# Access Compliance Report

## Public Rights-of-Way

Intersection ID: 4516	Main Street: ASTORIA_DR	Cross Street: DASHIEL_DR	Location: NW
ADA ID: 3FB8FE610464	Ramp Type: BlendTrans1	Initial Pass/Fail: Fail	Overall Compliance: No
		Severity Score: 10

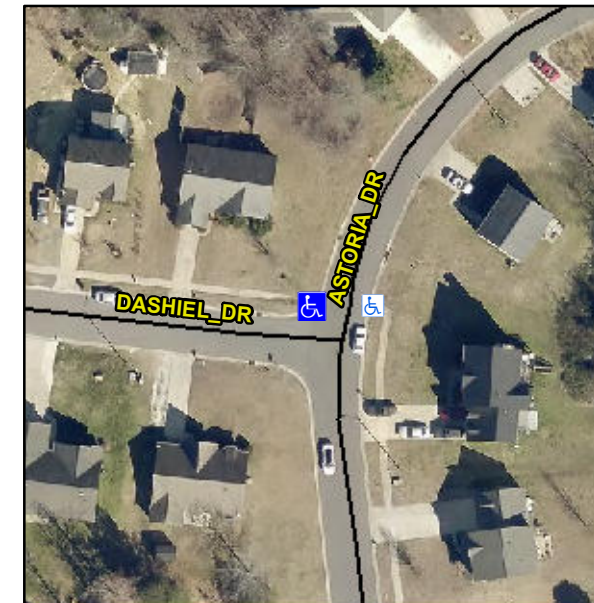
**Not Found, R304.5.1, R304.5.3**

Compliance	Description	Data	Compliance	Description	Data
N/A	Ramp Length (in)	48.0	Yes	BlendTrans Slope (%)	2.3
No	Ramp Width (in)	44.0	No	BlendTrans XSlope (%)	4.0
N/A	Flare Type LT	N/A	N/A	Flare Type RT	N/A
N/A	Flare Slope LT (%)	N/A	N/A	Flare Slope RT (%)	N/A
N/A	Flare Traversable LT?	N/A	N/A	Flare Traversable RT?	N/A
N/A	Landing Length (in)	N/A	N/A	DWS Provided?	N/A
N/A	Landing Width (in)	N/A	N/A	DWS Contrast?	N/A
N/A	Landing Slope (%)	N/A	N/A	DWS Length (in)	N/A
N/A	Landing X Slope (%)	N/A	N/A	DWS Full Width?	N/A
N/A	Landing Curb? (Y/N)	N/A	N/A	DWS Offset (in)	N/A
N/A	Shared Landing?	N/A			
N/A	Gutter Ponding?	N/A	N/A	Gutter Slope (%)	N/A
N/A	Gutter Lip Ht (in)	N/A	N/A	Gutter X Slope (%)	N/A
N/A	Painted X Walk1?	No	N/A	Painted X Walk2?	N/A
	X Walk 1 Direction	To E		X Walk 2 Direction	N/A
	X Walk 1 Width (in)	N/A		X Walk 2 Width (in)	N/A
	X Walk 1 Slope (%)	2.2		X Walk 2 Slope (%)	N/A
	X Walk 1 X Slope (%)	0.6		X Walk 2 X Slope (%)	N/A

**Remove & Replace Curb Ramp With Two New Directional Ramps or Equivalent.**
